1712 FAIRFIELD ROAD

SUMMARY OF REVISIONS

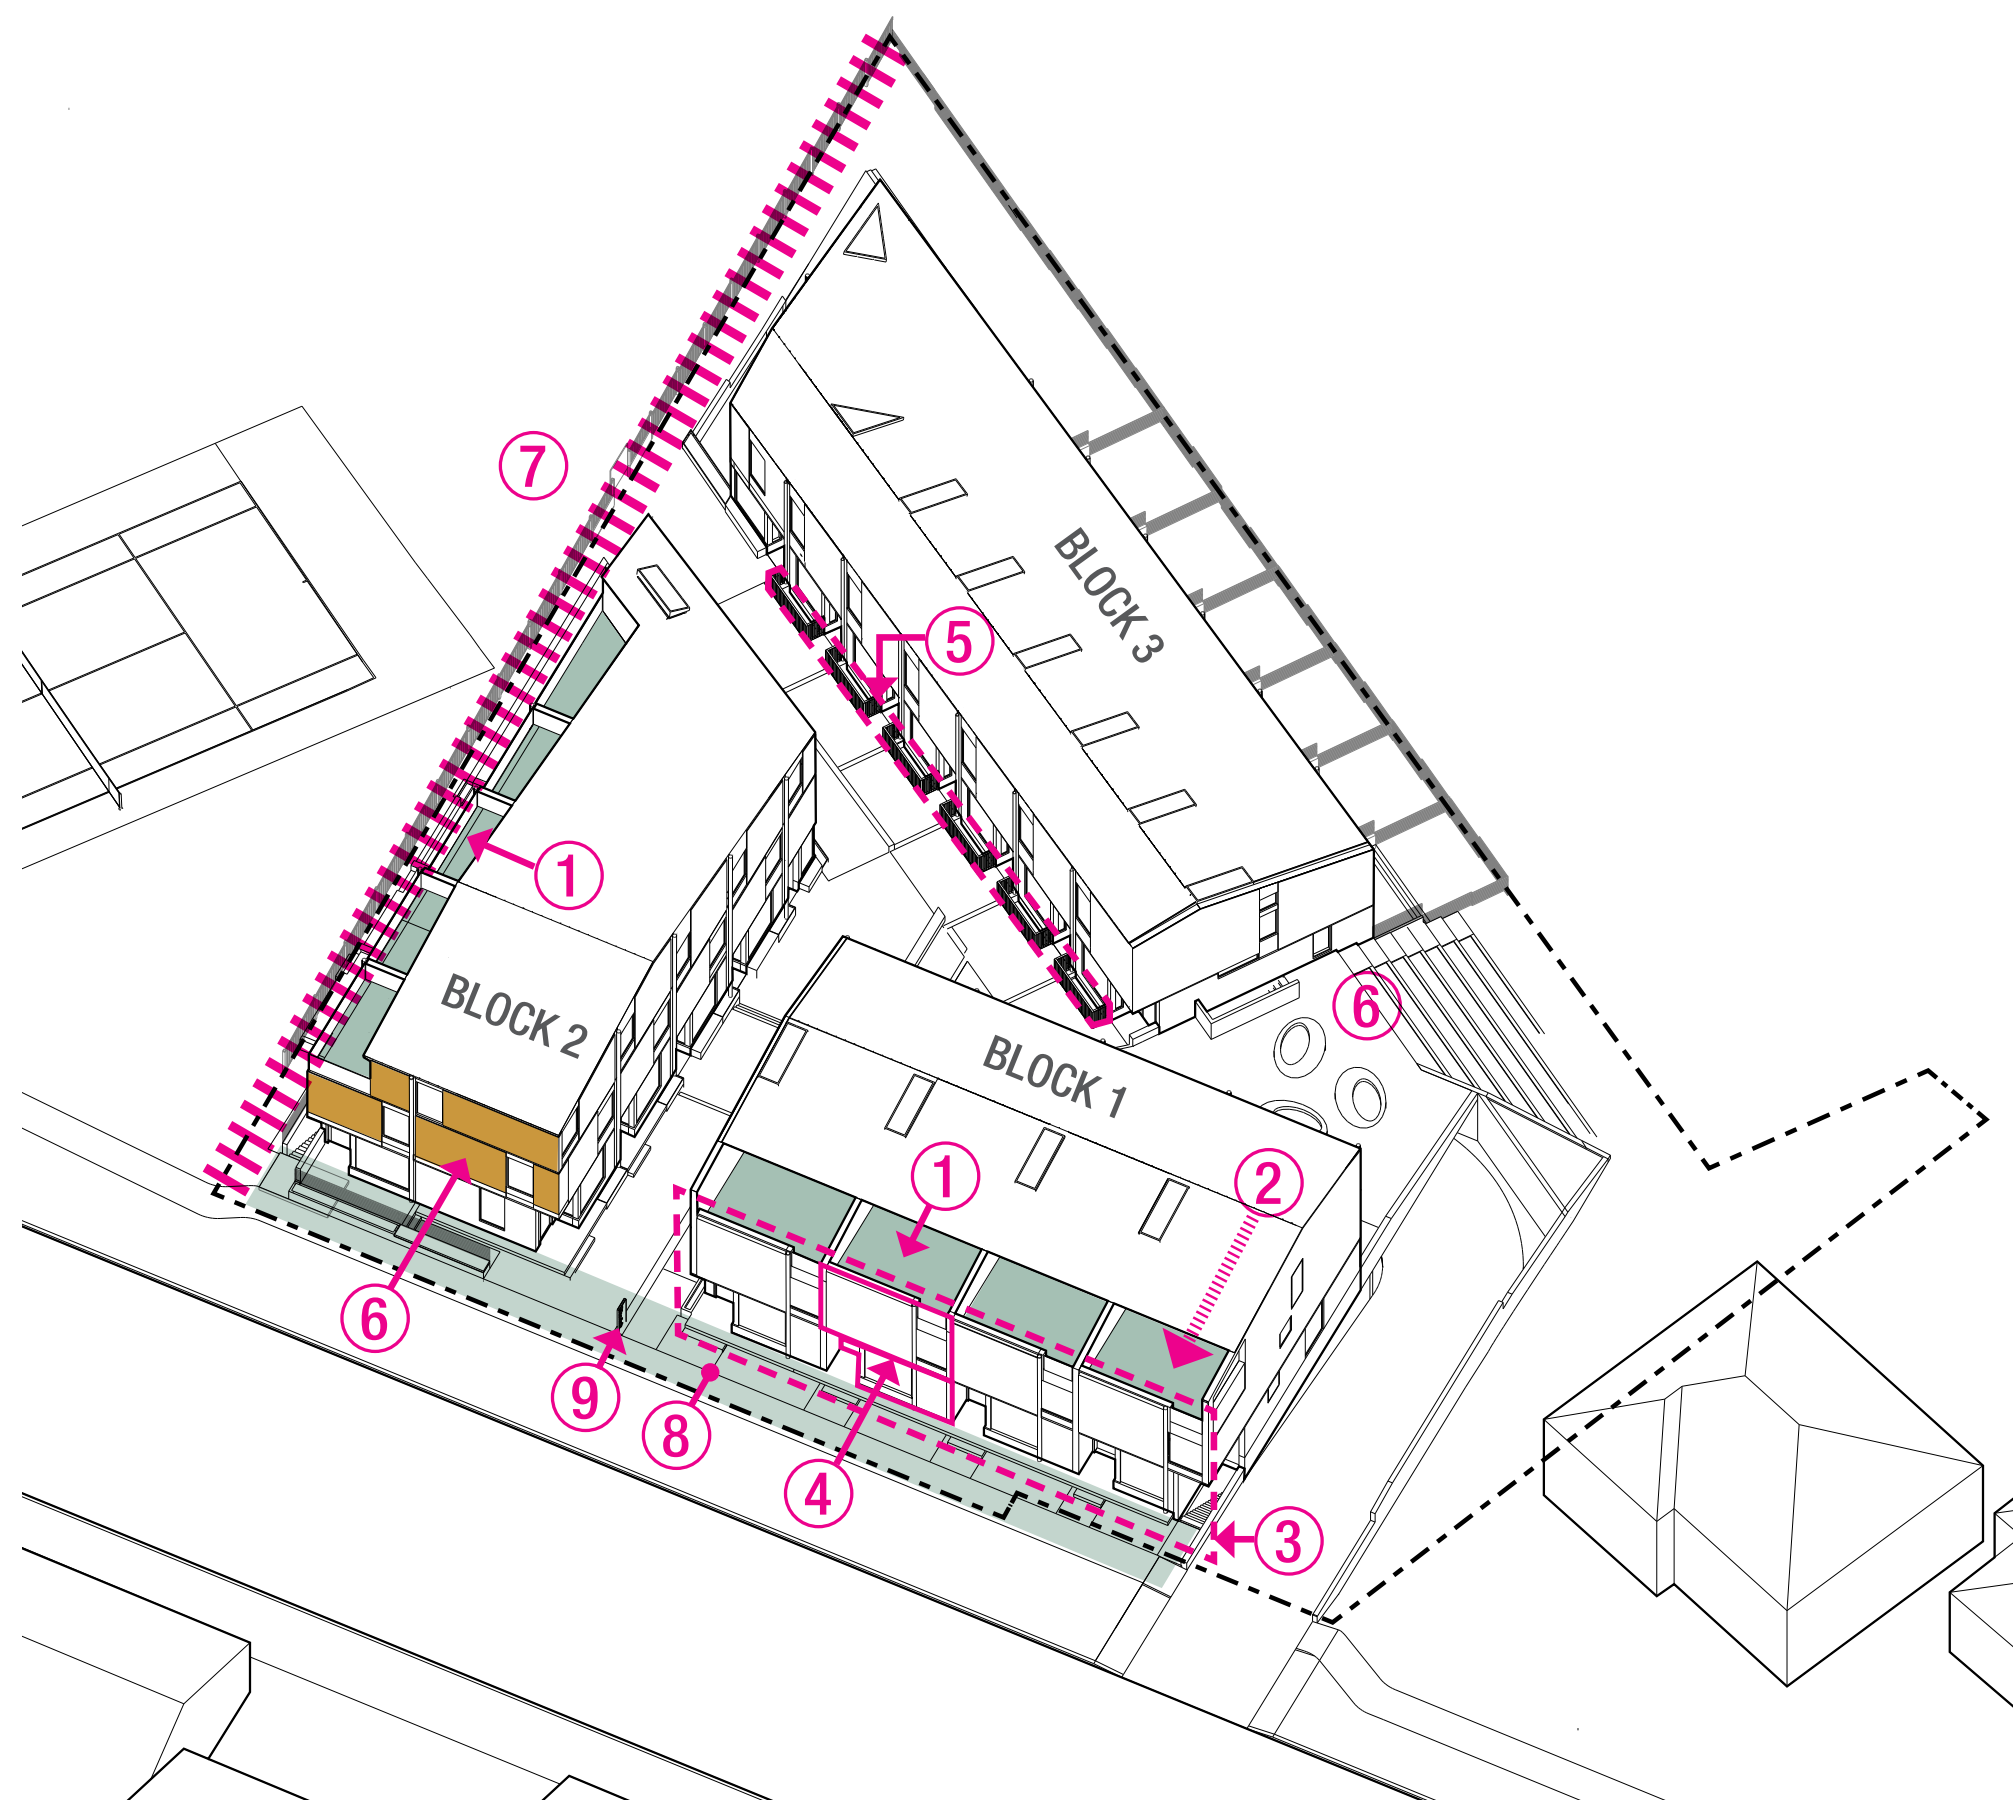
- 1 Block 1+2 balconies face outwards to reduce apparent scale of development
- 2 Roofline lowered along Fairfield Road and Hollywood Park
- 3 Facade expression is simplified

- 4 Block 1 consists of 1 bedroom ground oriented units + 2 bedroom 2 storey stacked units above.
- 5 Additional bedroom added below grade at Unit B3 with lightwell to form 3 bedroom 2 storey (above grade) units.

- 6 Buildings will be clad in primarily Cedar shingles above level 1
Vertical Cedar cladding will appear within recessed balcony areas only

- 7 Cedar hedges and fencing added along park to serve as landscape buffers
- 8 Landscape along Fairfield road has been refined
- 9 Development signage has been reduced in size
